AW: Replacement capacitor

We have recently performed a field service visit for 6 Ceratherm 600-3 units that we supplied to a customer in 2013.

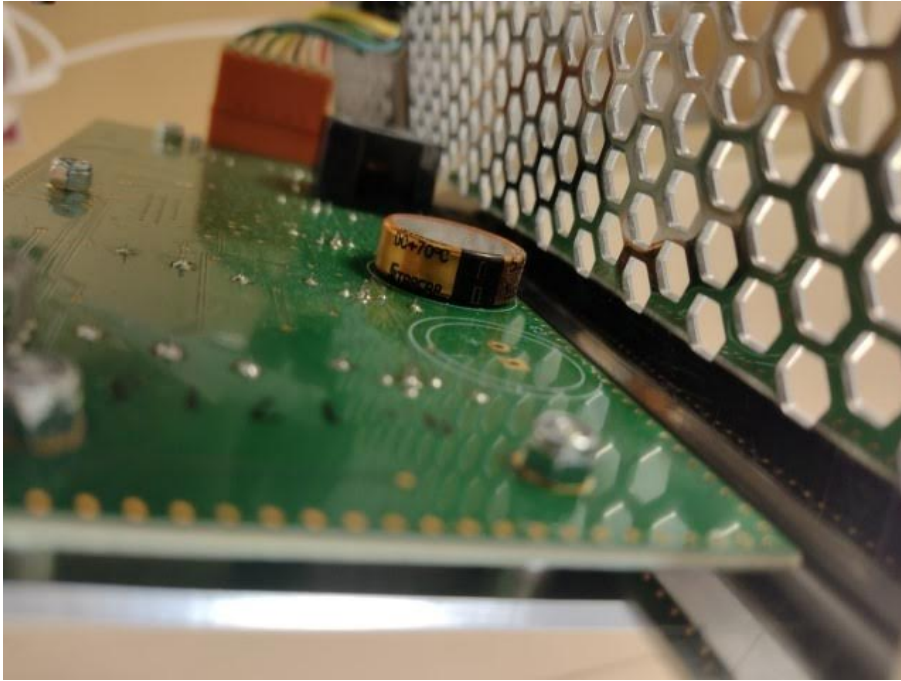
All 6 devices failed to meet the requirement of the power disconnect alarm sounding for 10 minutes without power.

I assume that replacing the controller PCB will resolve this issue, but that is a very expensive fix. Is there a simple solution?

Looking at the PCB, we can see that there is a capacitor on there. I don't have a wiring diagram but it seems very likely that this capacitor could be storing the charge to maintain the alarm in the event of a power failure.

Would a simple replacement of this capacitor fix the problem? And if so, do you supply it or can you give me the capacitor specification so that we can try it?

However, the customer can replace the energy storage device (super capacitor) if necessary. This component can be procured on the market (available from various manufacturers) and must comply with the following specifications:

Super Capacitor (C16 on CPU-Board)

Capacity: **1.0 F**

Dielectric strength: **5.5 V**

Temperature range: **85 °C**

Pitch: **7.5 mm**

Diameter: 20mm (other dimensions possible)

Height: 11mm (other dimensions possible)

Yes, you are right. This capacitor is responsible for maintaining the alarm in the event of a power failure.
